### ZION STATION UNIT 1

# AMENDMENT TO FACILITY OPERATING LICENSE

Amendment No. 53 License No. DPR-39

AMENDMENT NO. 53 TO FACILITY OPERATING LICENSE NO. DPR-39 AMENDMENT NO. 50 TO FACILITY OPERATING LICENSE NO. DPR-48 DOCKET NOS. 50-295 AND 50-304

Figure 3.2-9

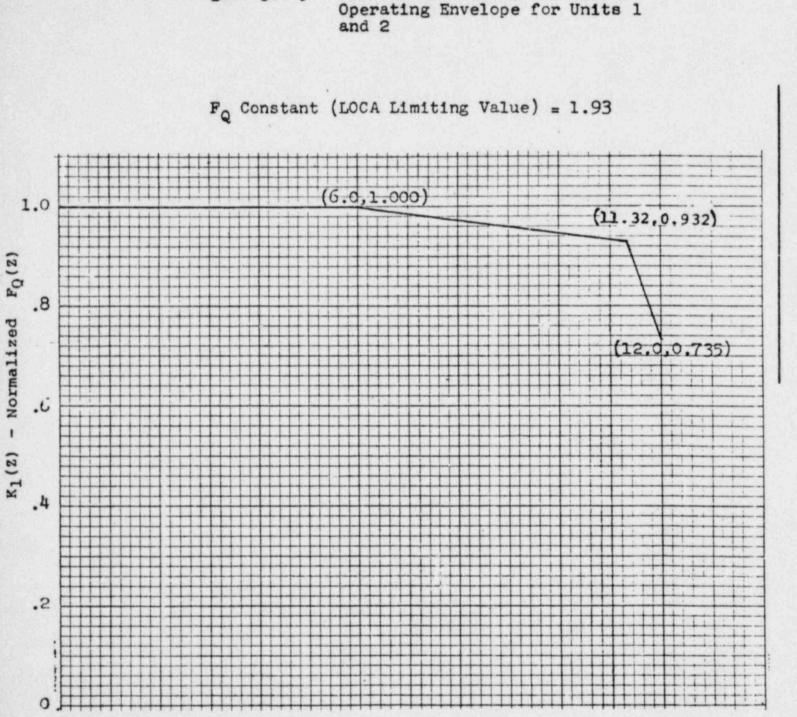
P = fraction of rated power at which the core operated during $F_Q$ and $F_{\Delta H}^N$ measurement;	met, in the full power con- figuration before a unit is operated above 75% of rating.
	<pre>K1(2) = factor from Figure 3.2-9 selected at the core elevation, 2, of the measured FQ;</pre>
